ADDENDUM NO. 3

City of Tukwila, Washington S Boeing Access Road over Airport Way Bridge Seismic Retrofit Project

City Project No.: 91310407

DATE OF ADDENDUM ISSUE: March 31, 2020

C1
4 of 23

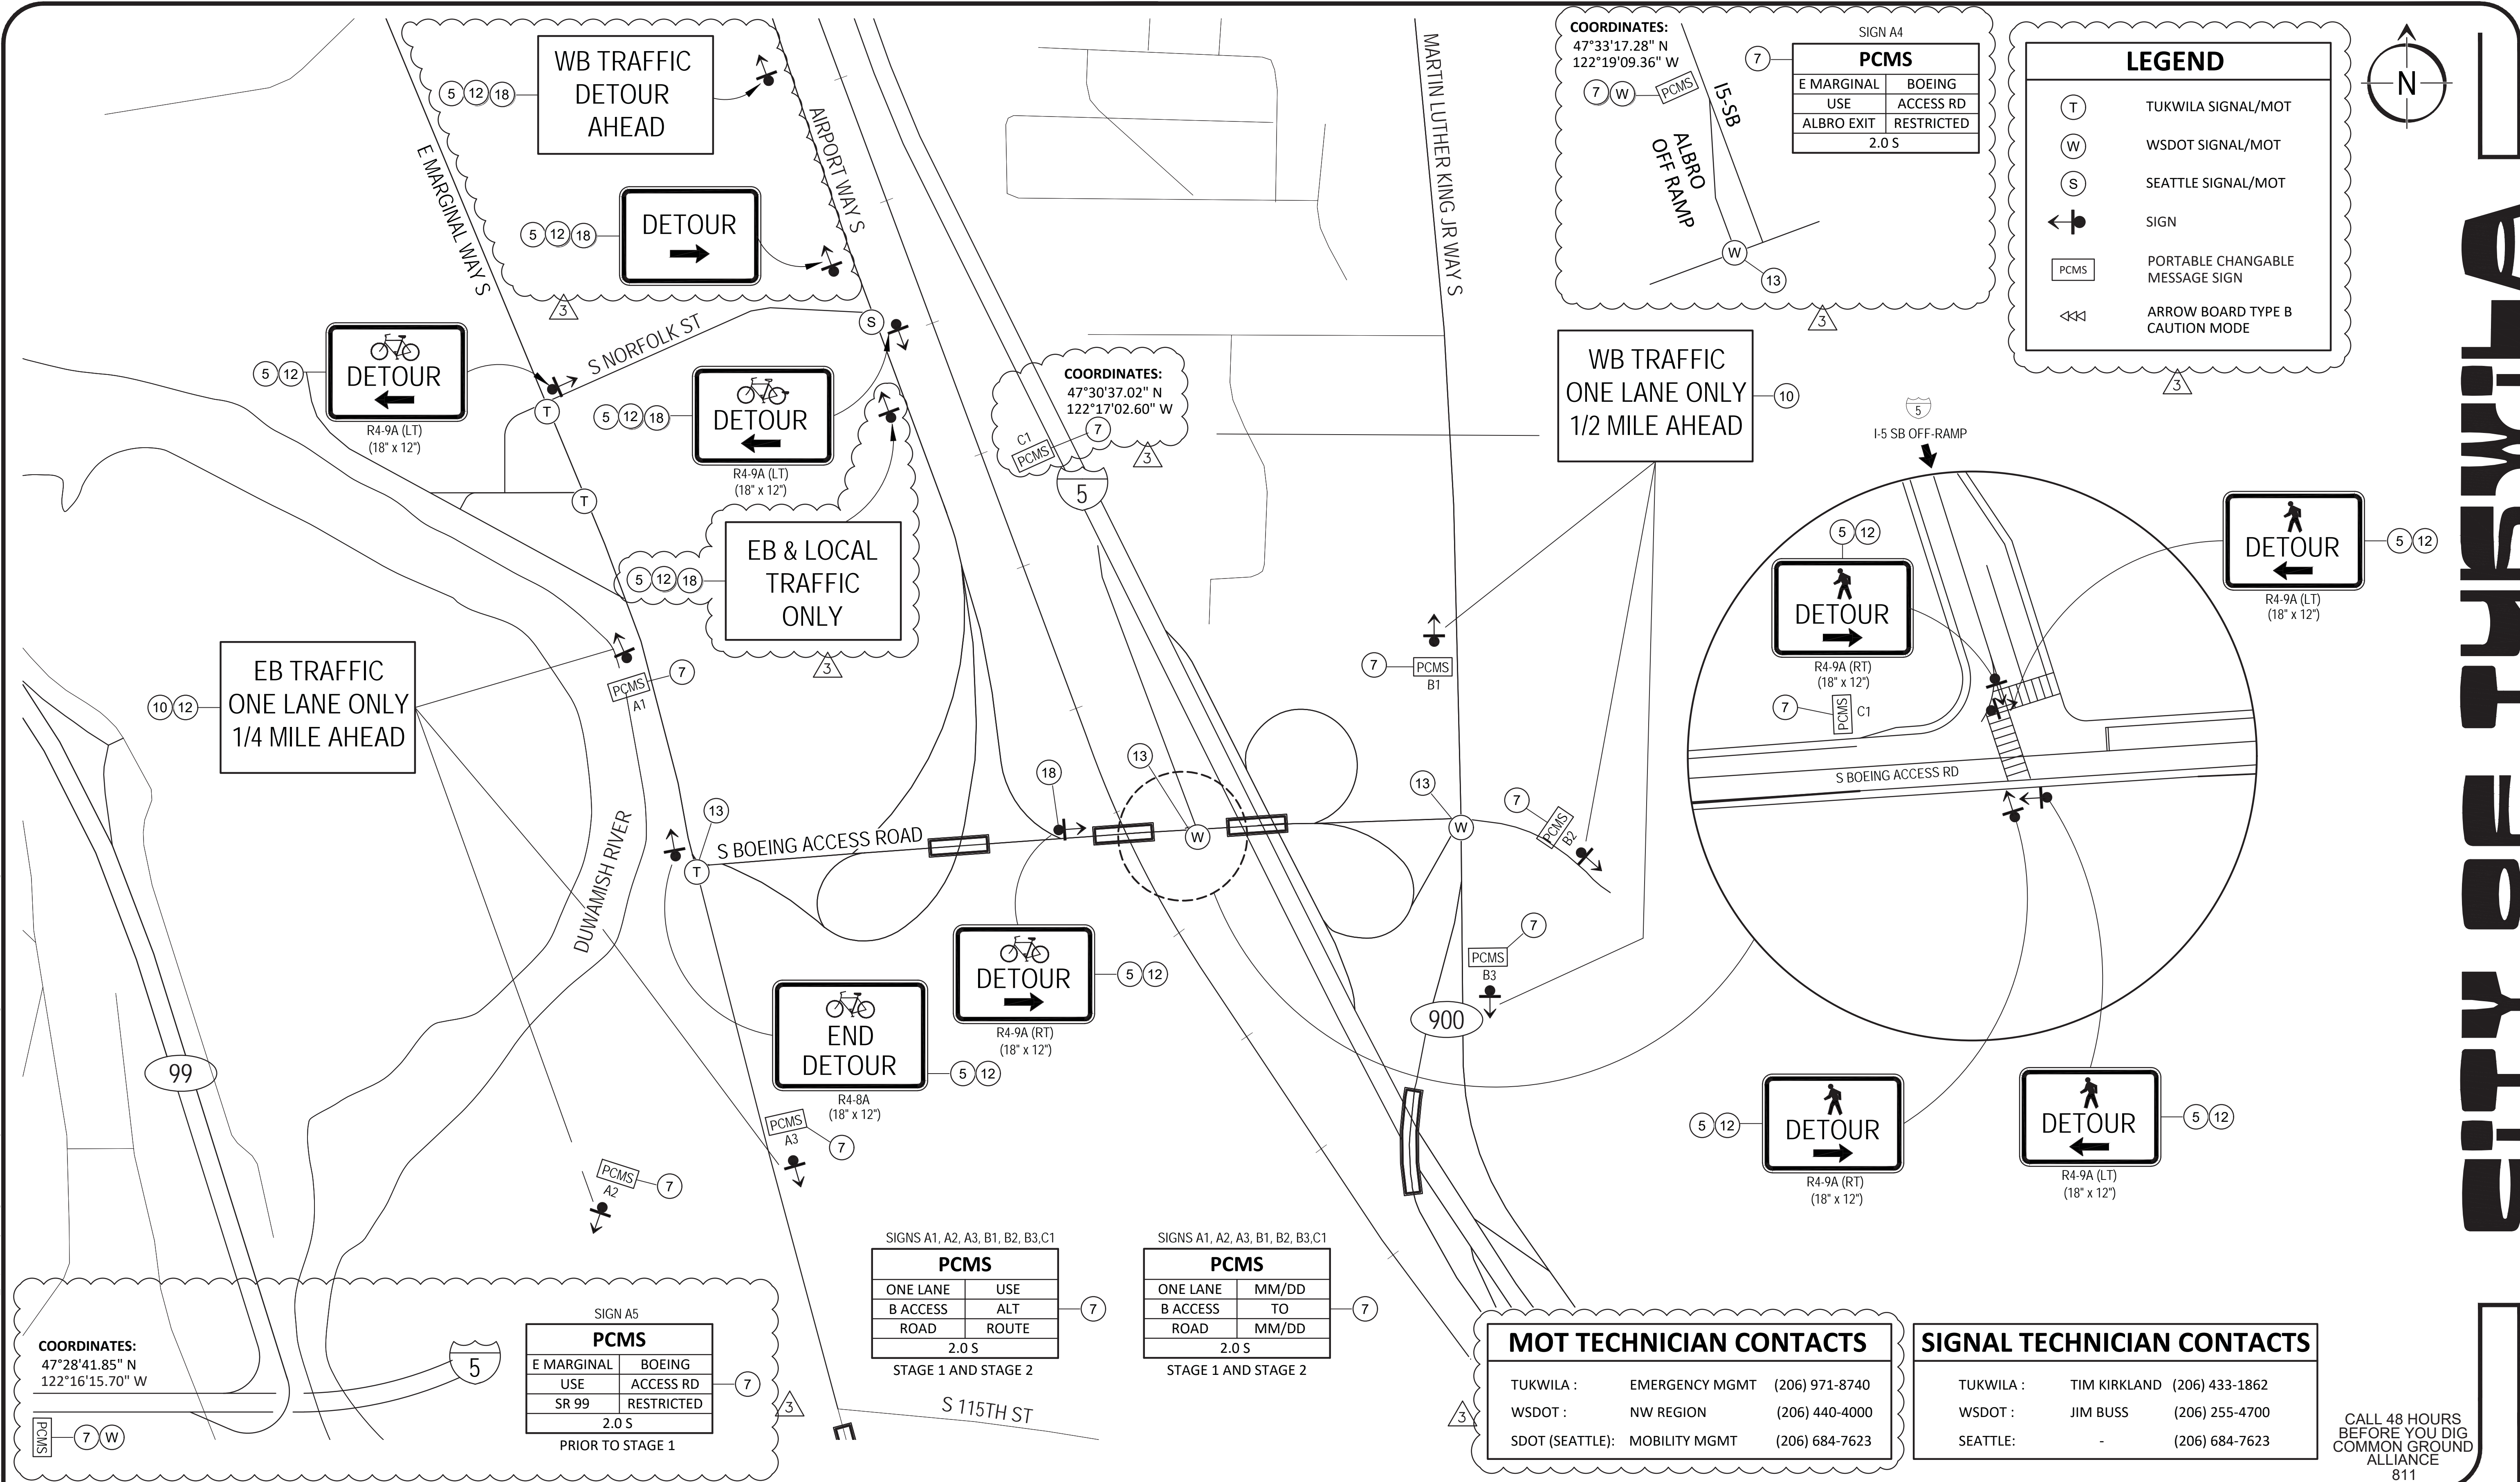
1. Plan Sheet 4 of 23:

DELETE Sheet 4 of 23 and REPLACE with the attached Sheet 4 of 23.

The following changes have been made:

- Note 19 added to General Notes.
- Construction Note 11 revised.

C2

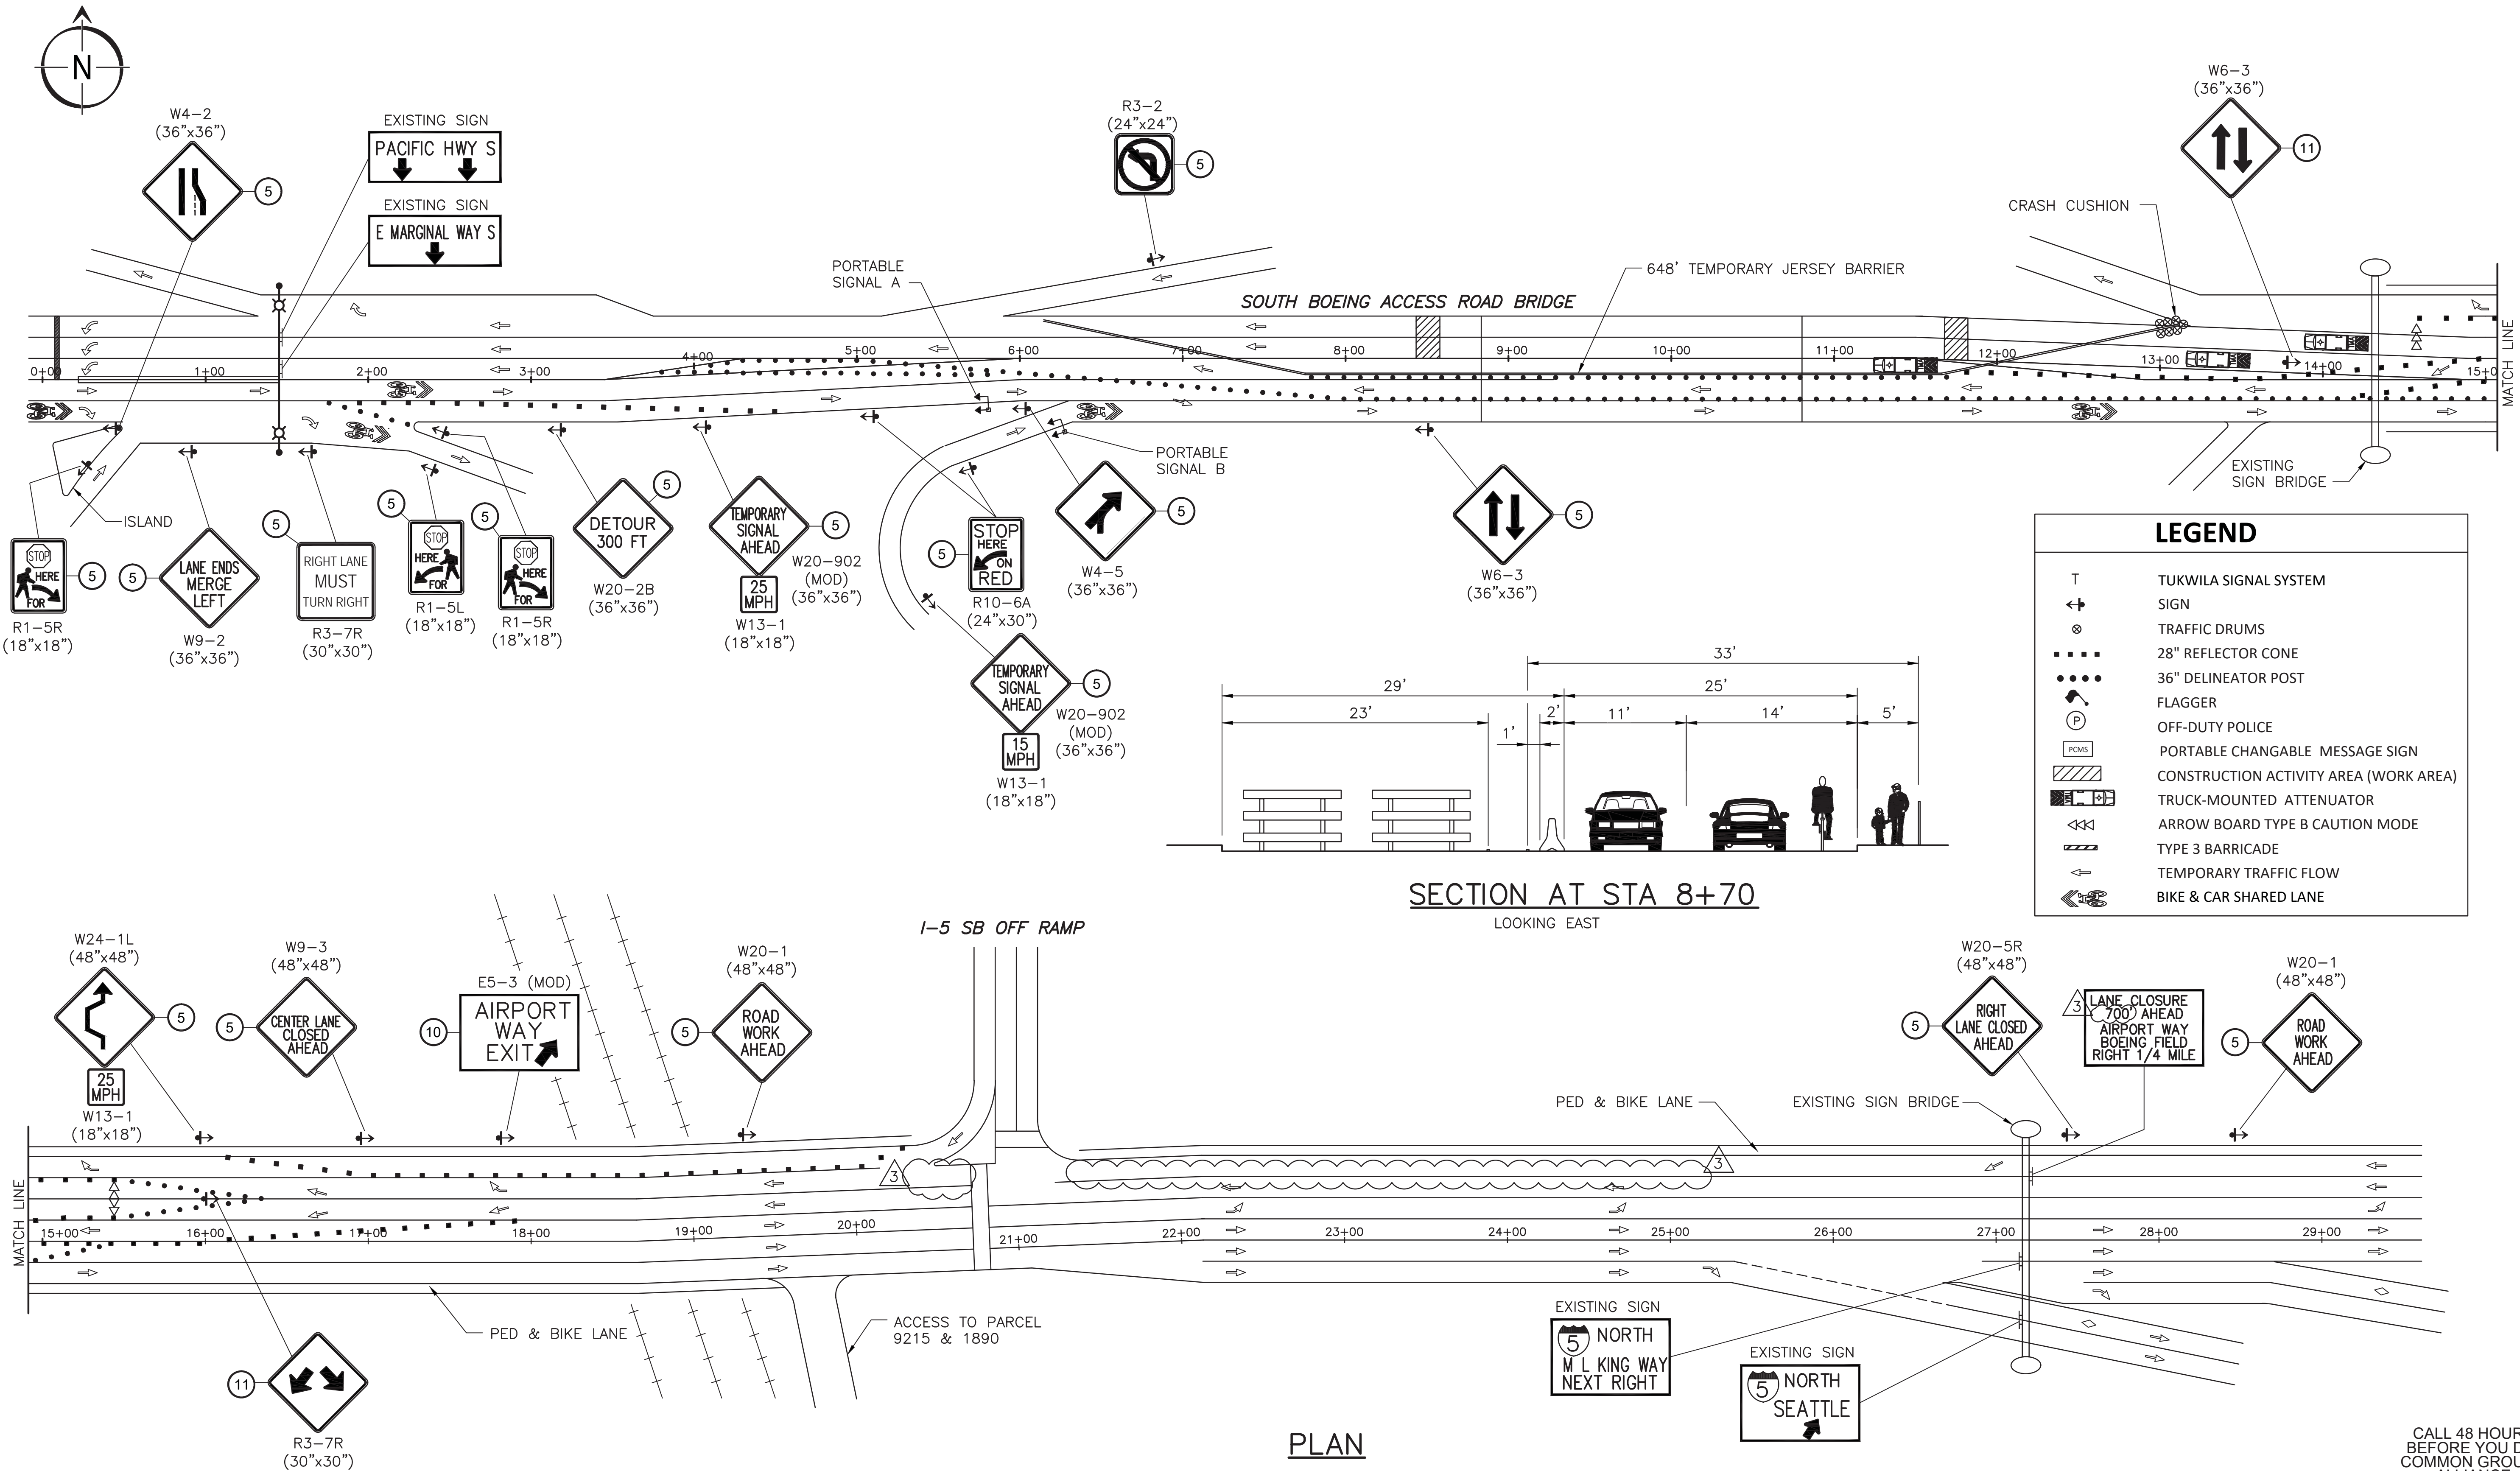
2. Plan Sheet 5 of 23:

DELETE Sheet 5 of 23 and REPLACE with the attached Sheet 5 of 23.

The following changes have been made:

- Additional detour signs added to Airport Way.
- Three PCMS signs added with coordinates for location.
- Arrow Board symbol added to the Legend.
- MOT contact list added.

C4
7 of 23
File No. C4&C5&C7&C8.dwg
Scale NTS
Date DEC. 2019

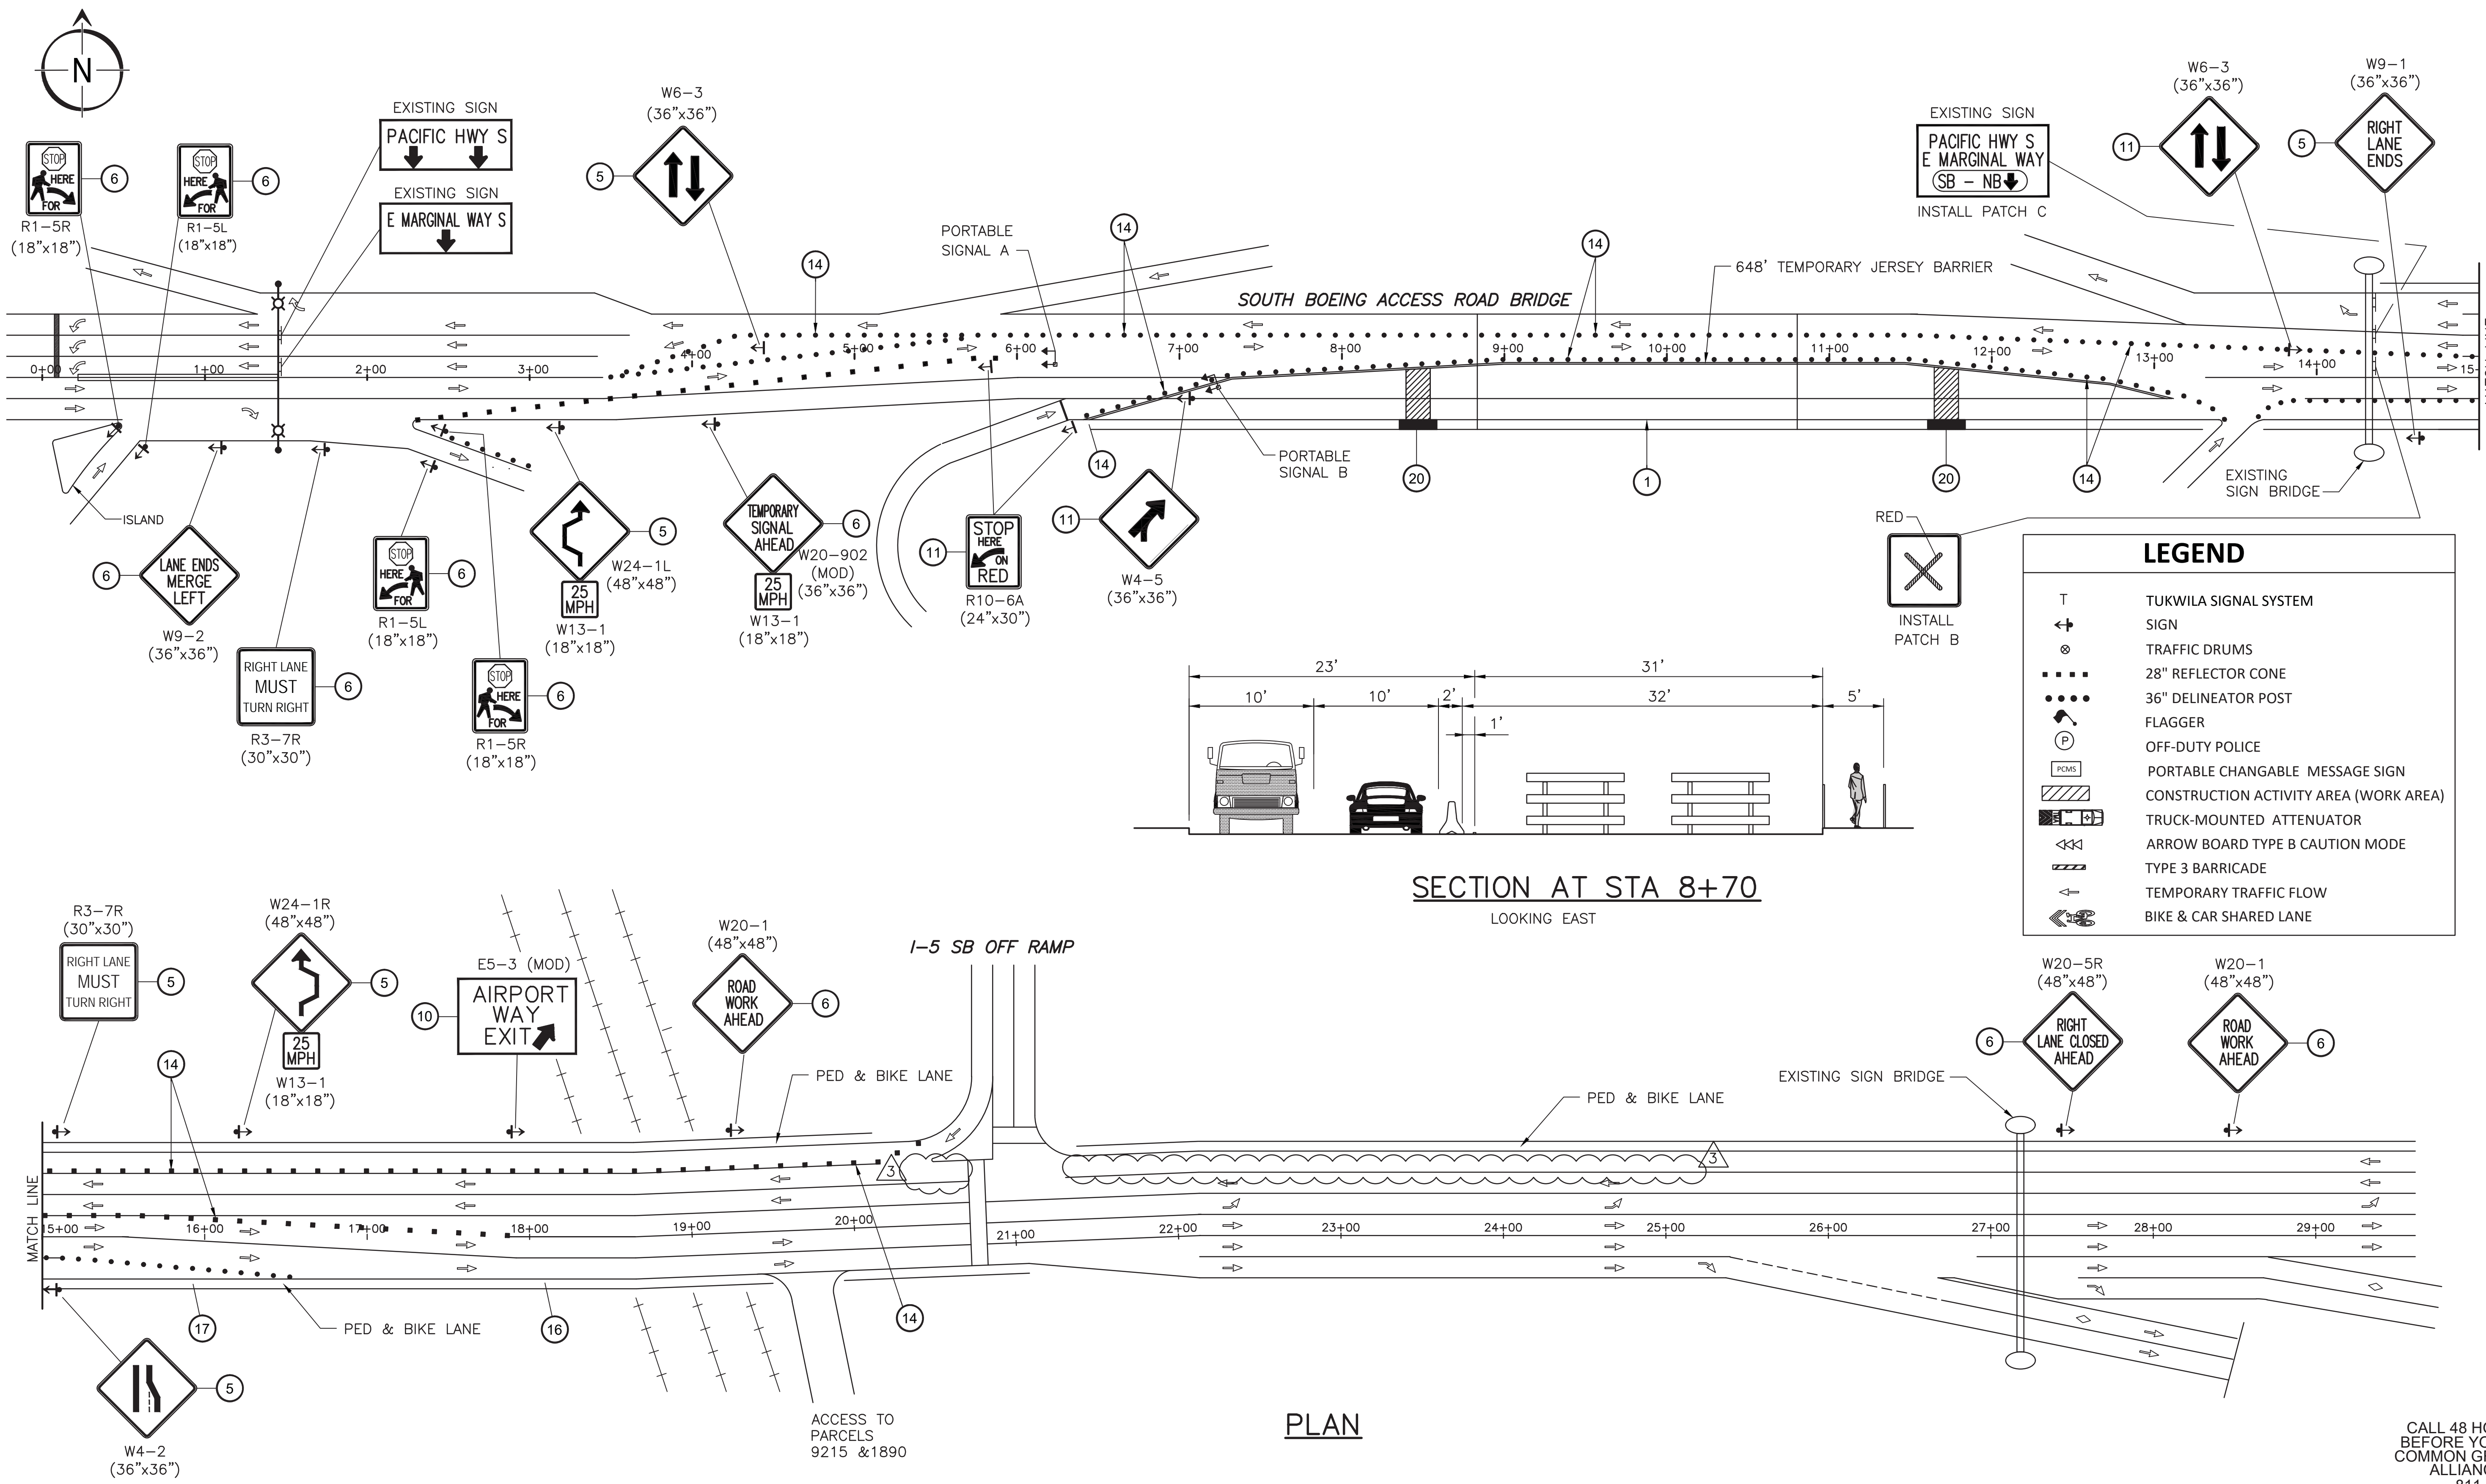
3. Plan Sheet 7 of 23:

DELETE Sheet 7 of 23 and REPLACE with the attached Sheet 7 of 23.

The following changes have been made:

- Removed lane closure and associated devices east of Southbound I-5 Offramp in westbound lane.
- Revised distance in overhead sign add-on.
